M-9A0 (Calpella + N11P/M Discrete Graphic)

FOXCONN		HON HAI Precision Ind. Co., Ltd.	
Title		ARD(Power)	
Size	Document Number	Rev	
Custom	M9A0 MP	1.1	
Date:	Wednesday, October 28, 2009	Sheet	5 of 73

FOXCONN		HON HAI Precision Ind. Co., Ltd.	
		CCPBG - R&D Division	
Title	PCH (PCI-E, SMBUS, CLK)		
Size	Document Number	Rev	
Custom	M9A0 MP	1.1	
Date:	Friday, October 23, 2009	Sheet	10 of 73

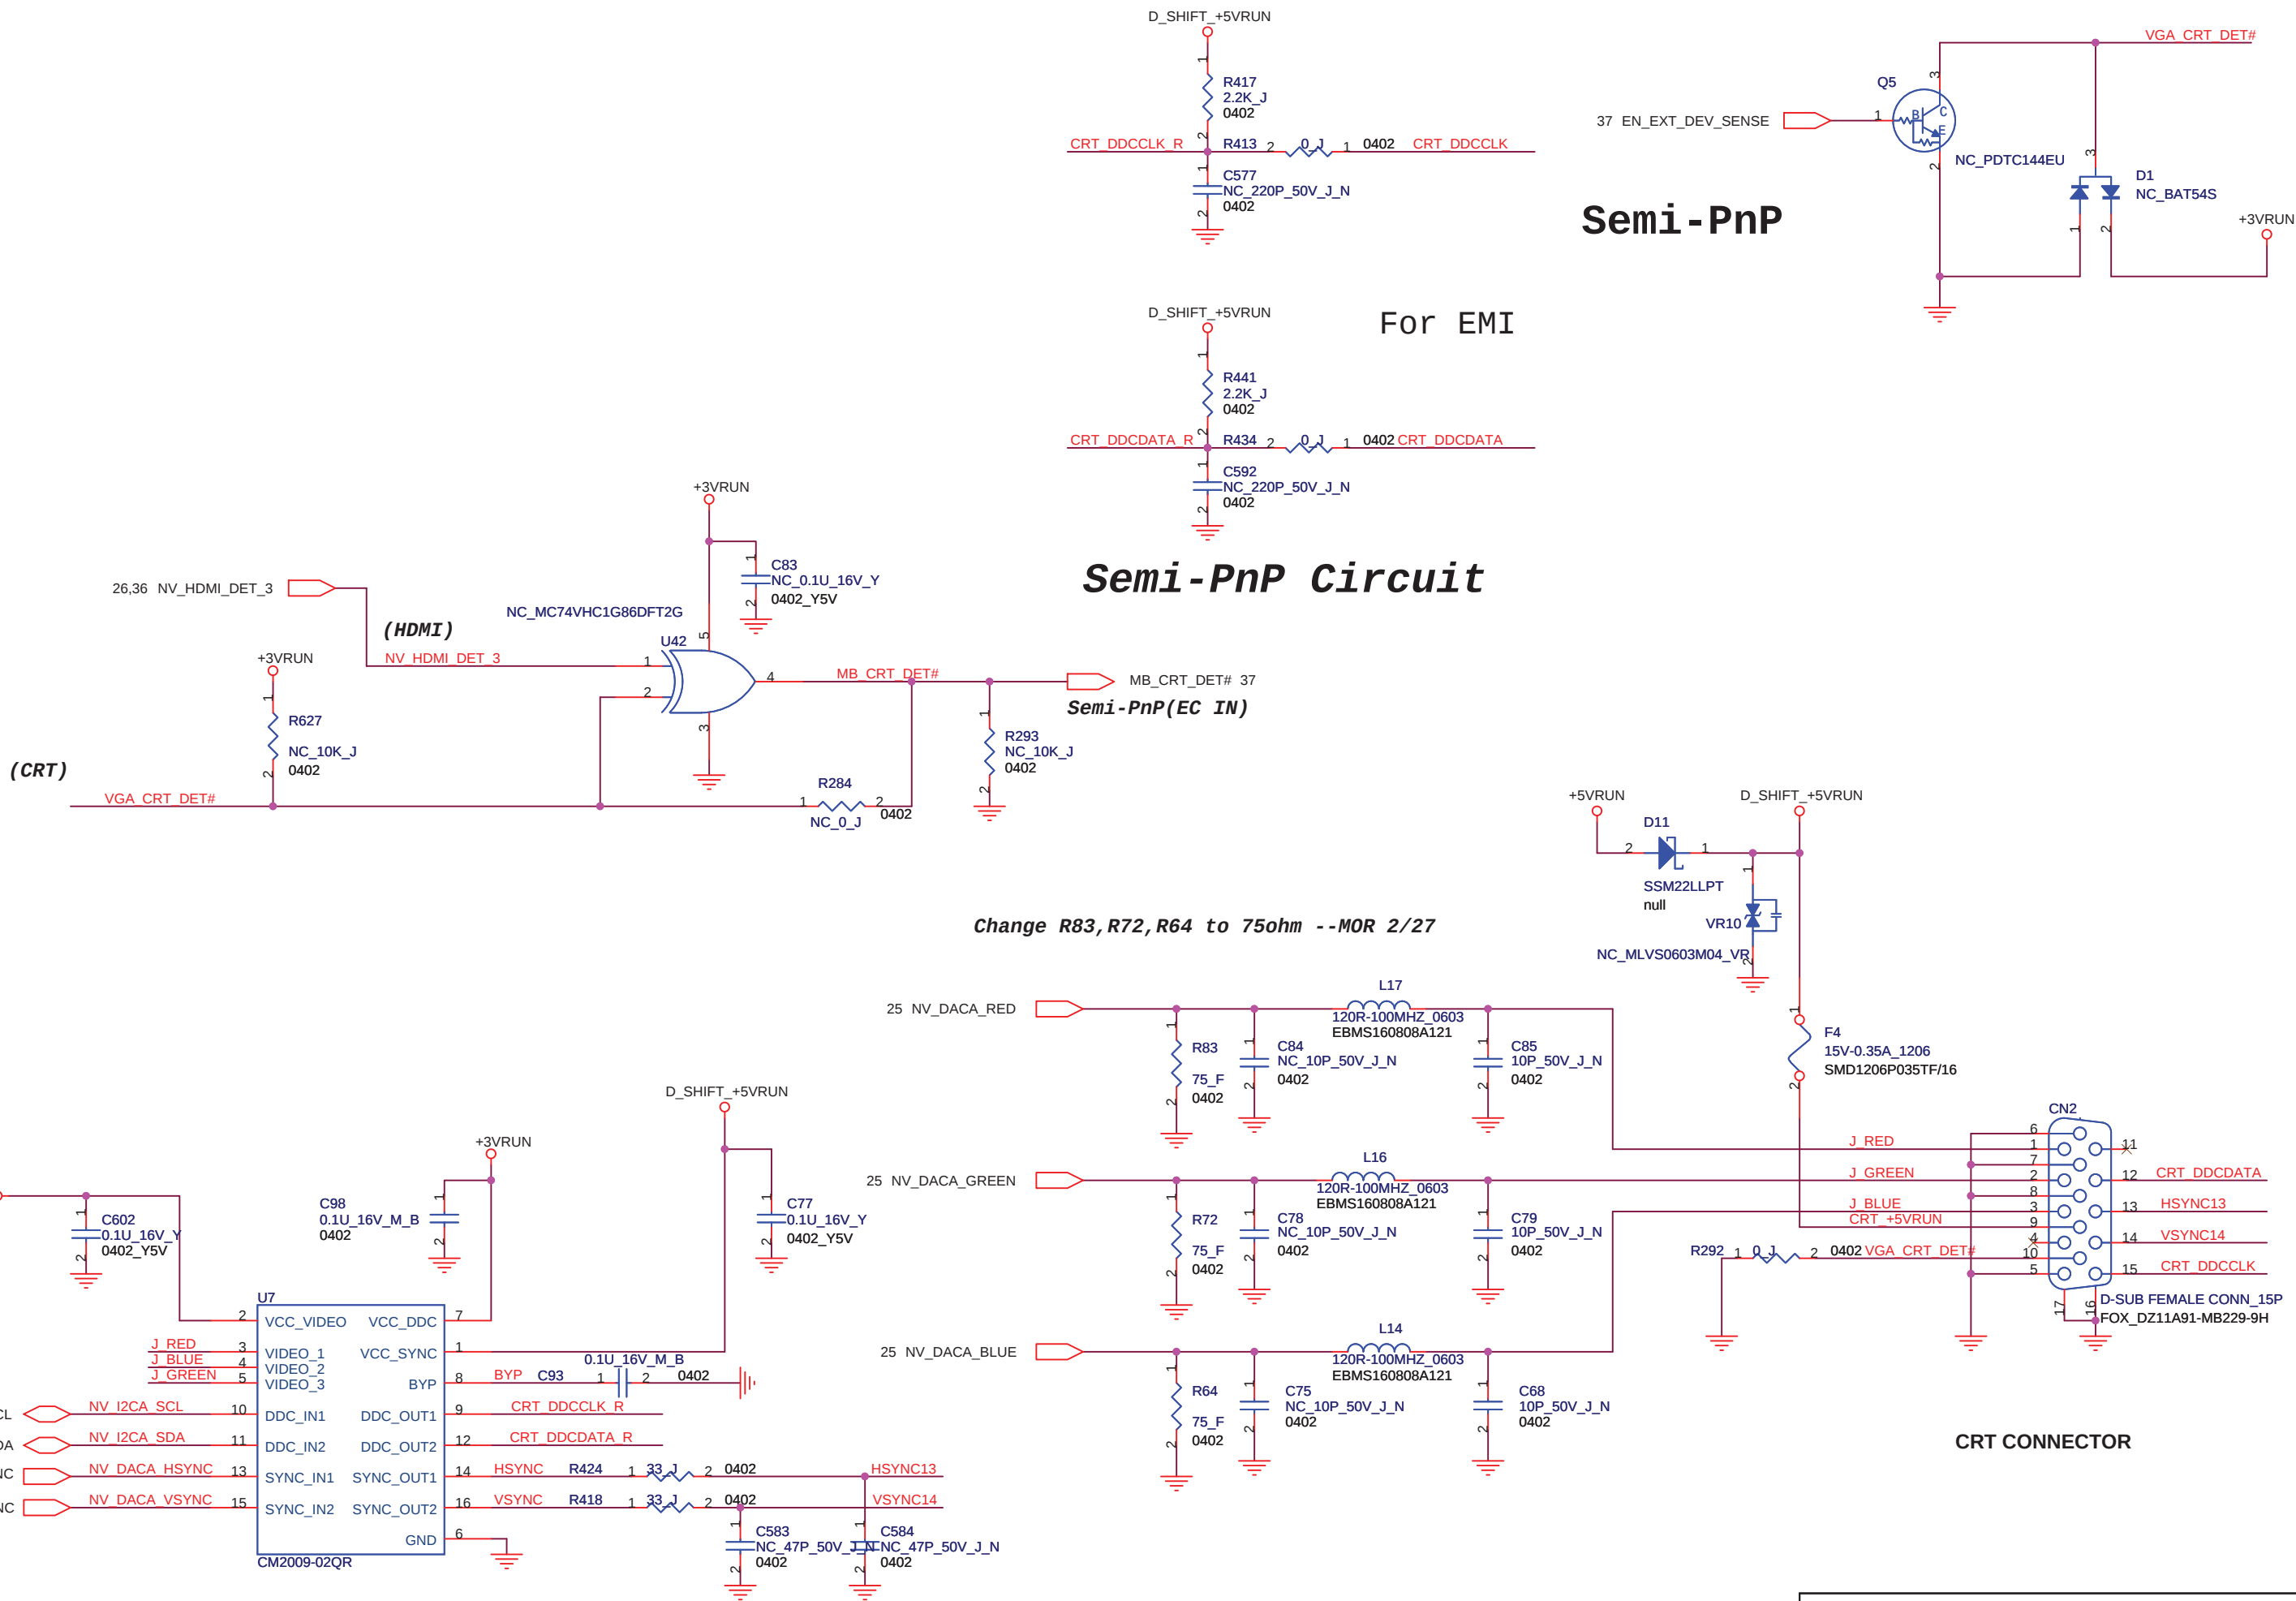
Change R83,R72,R64 to 75ohm --MOR 2/27

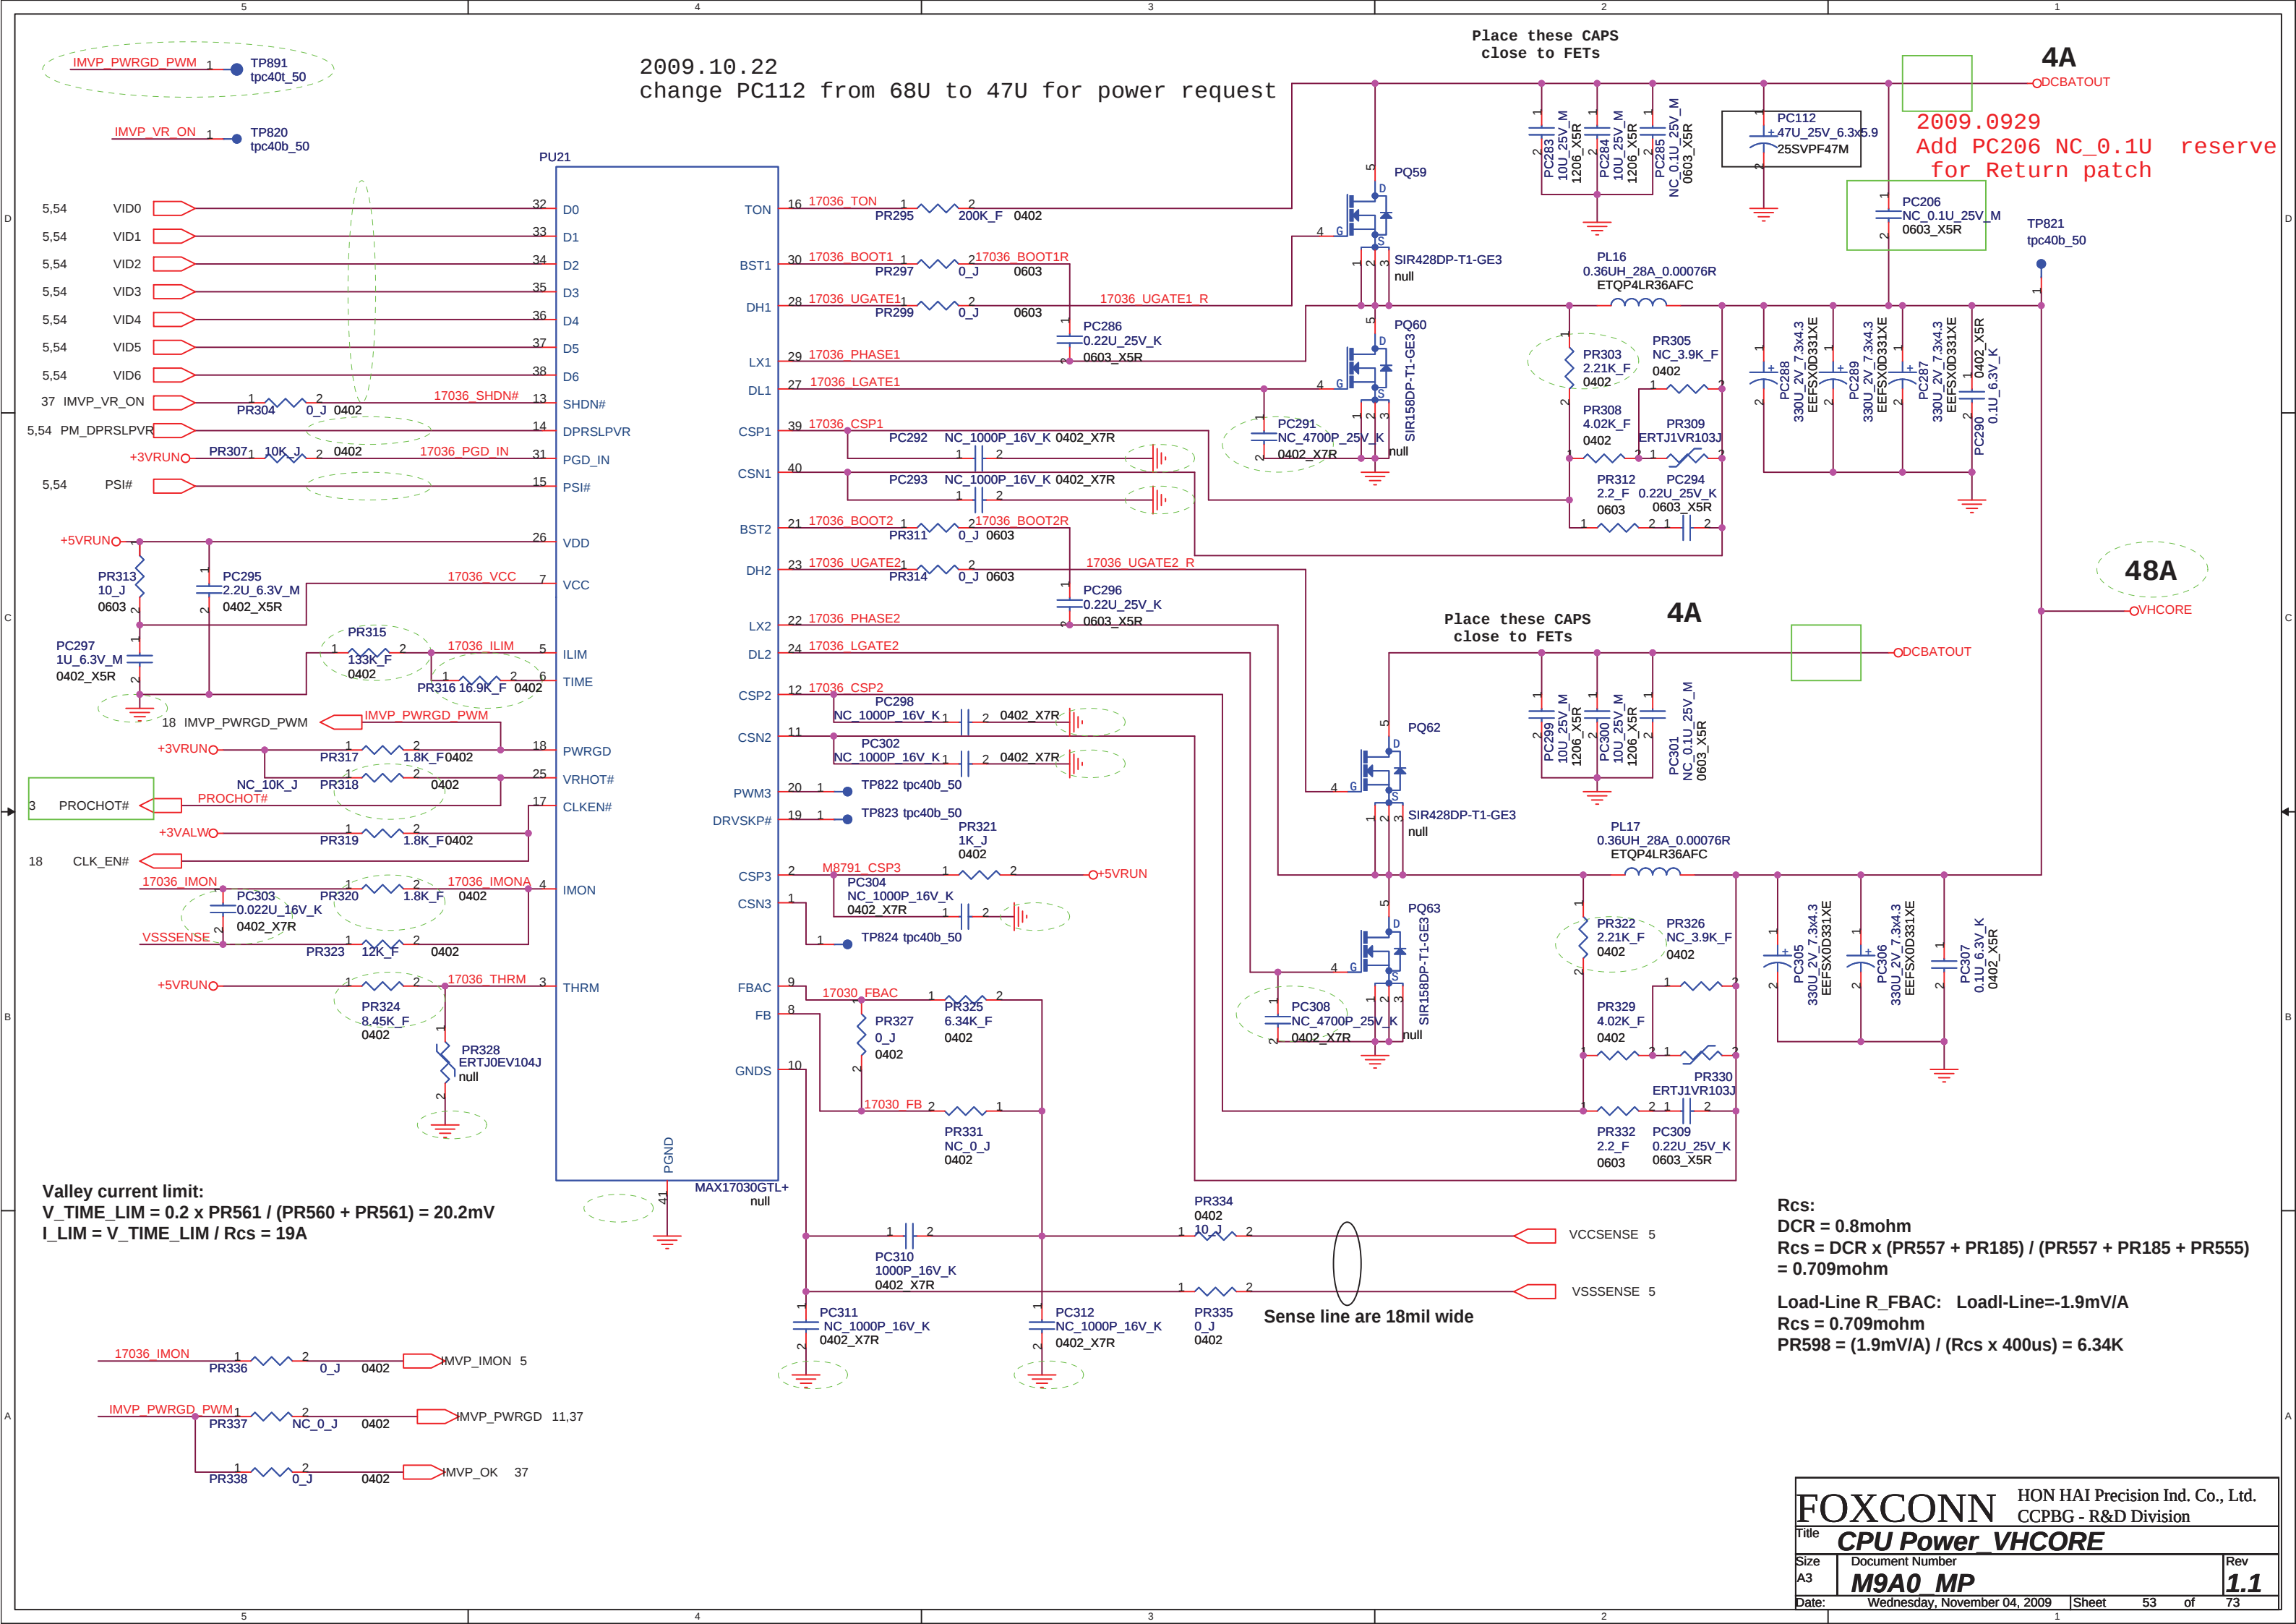
2009.10.22
change PC112 from 68U to 47U for power request

2009.0929
Add PC206 NC_0.1u reserve
for Return patch

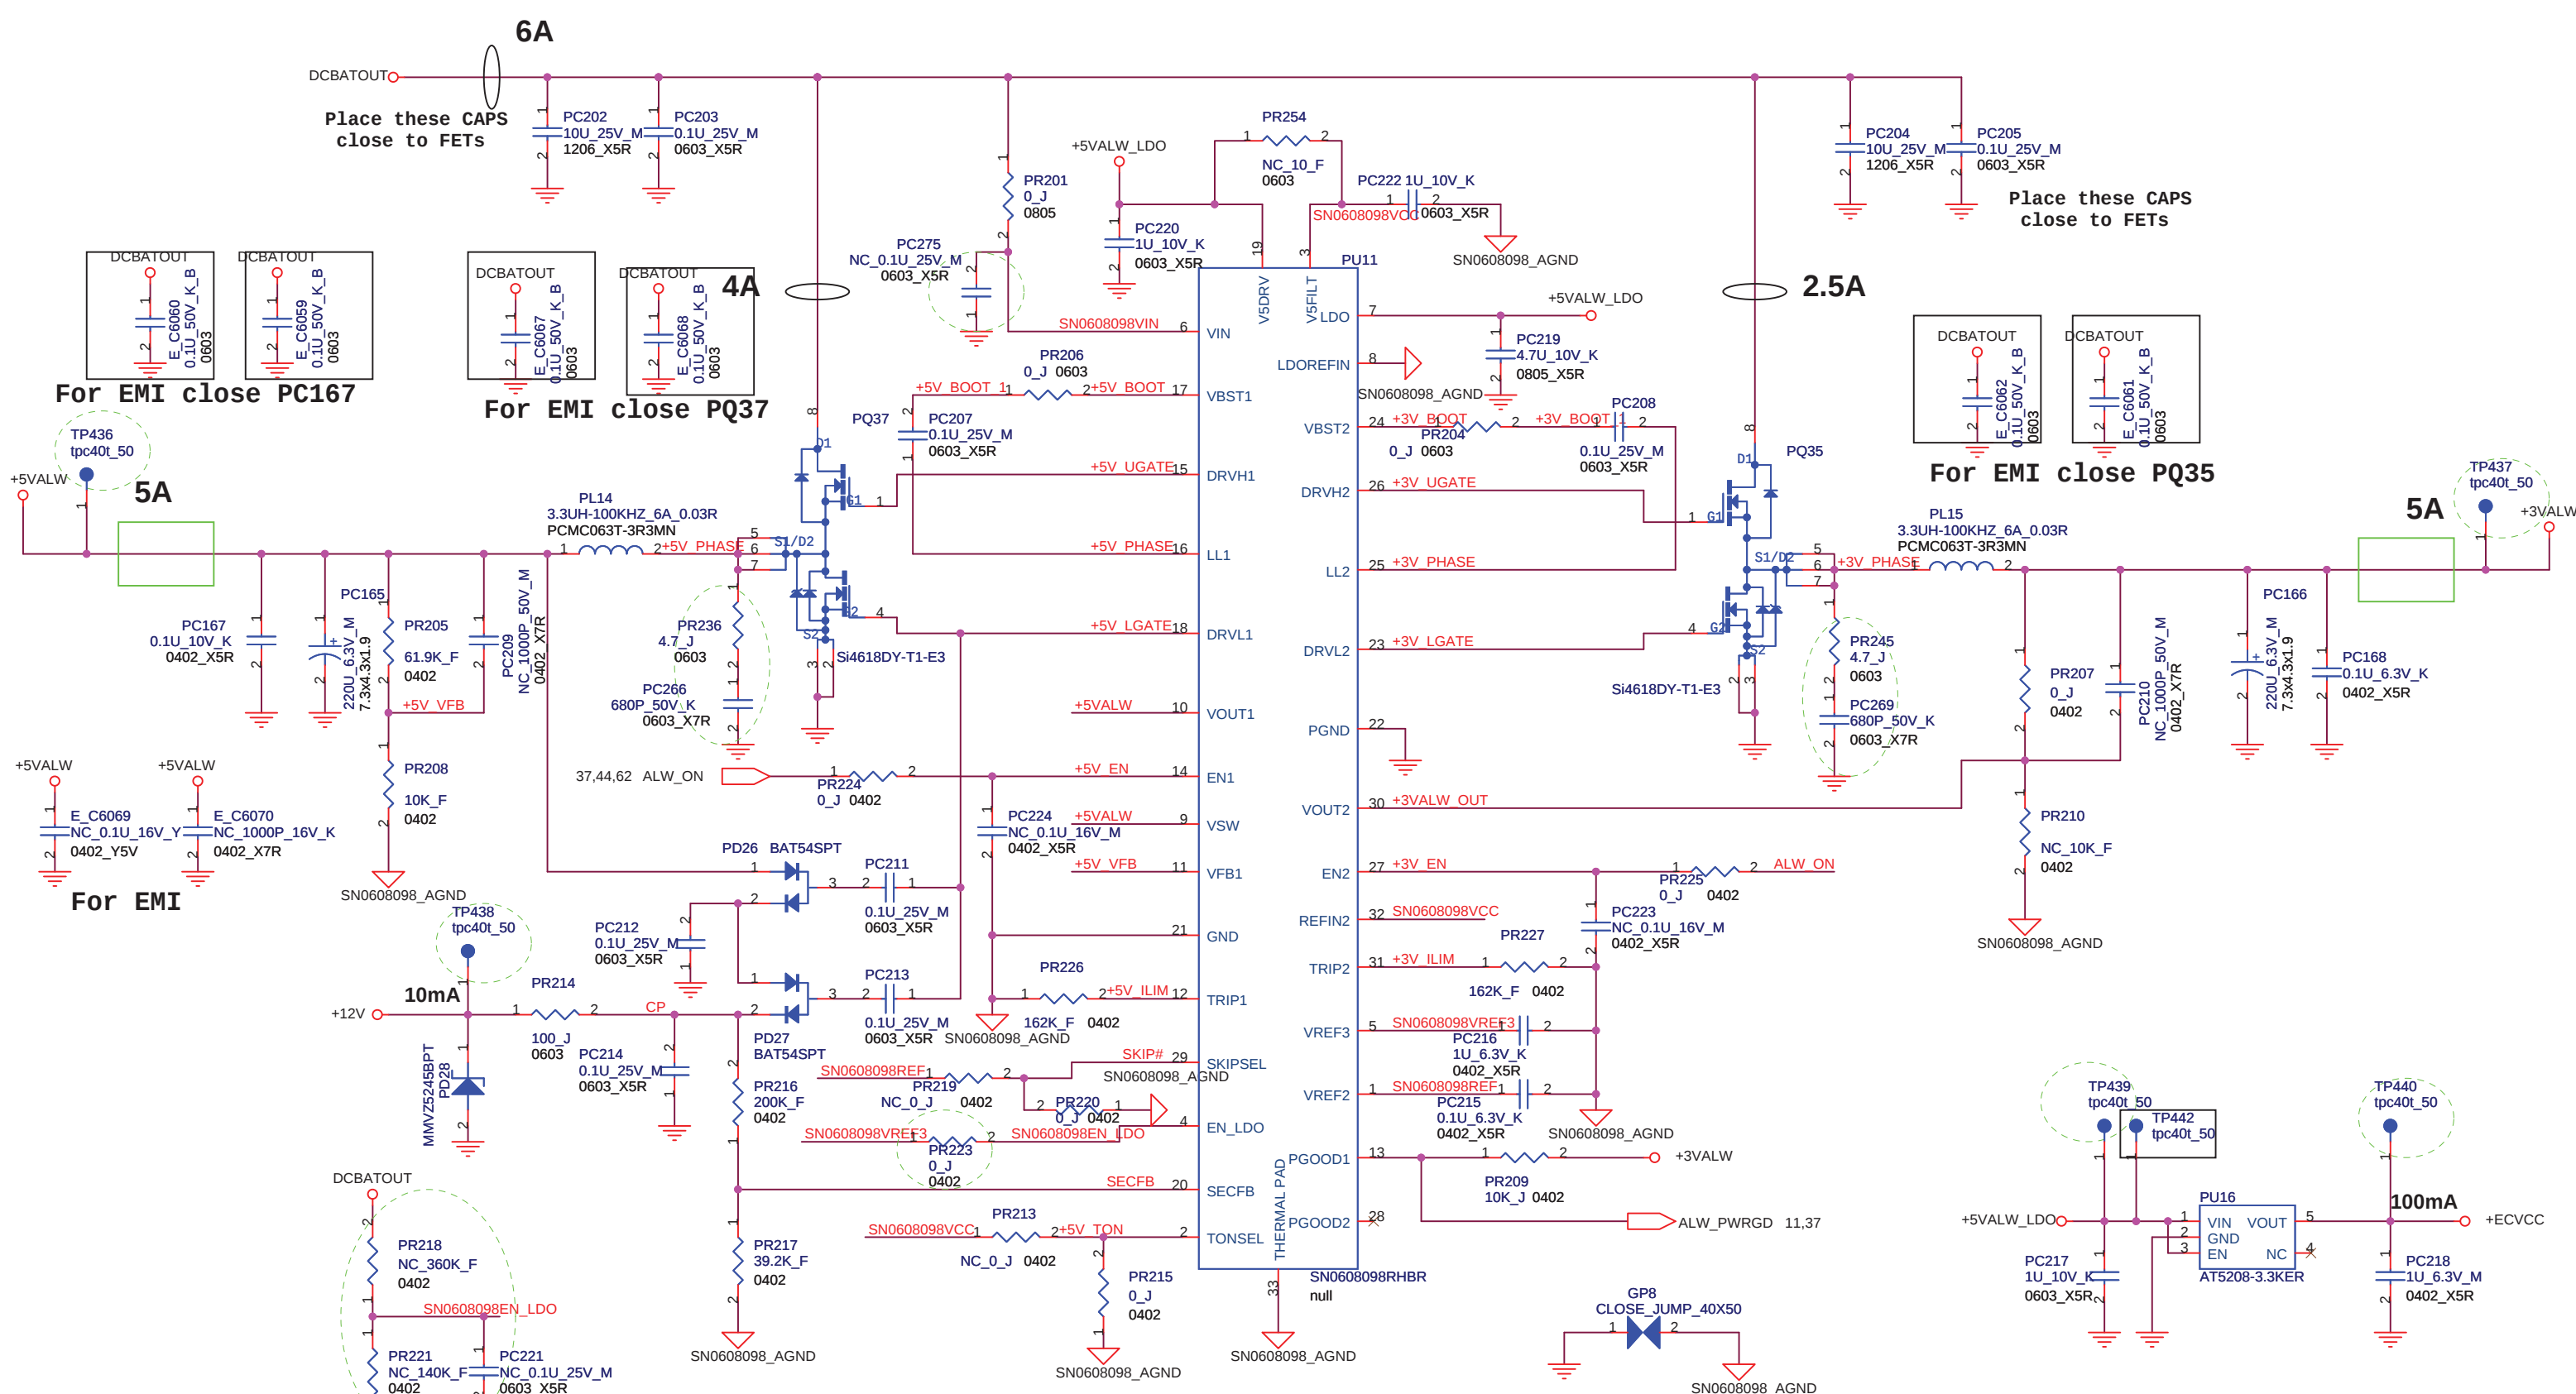
2009.0925
change PR245,PC269,PR236,PC266 from NC to mount for EMI request
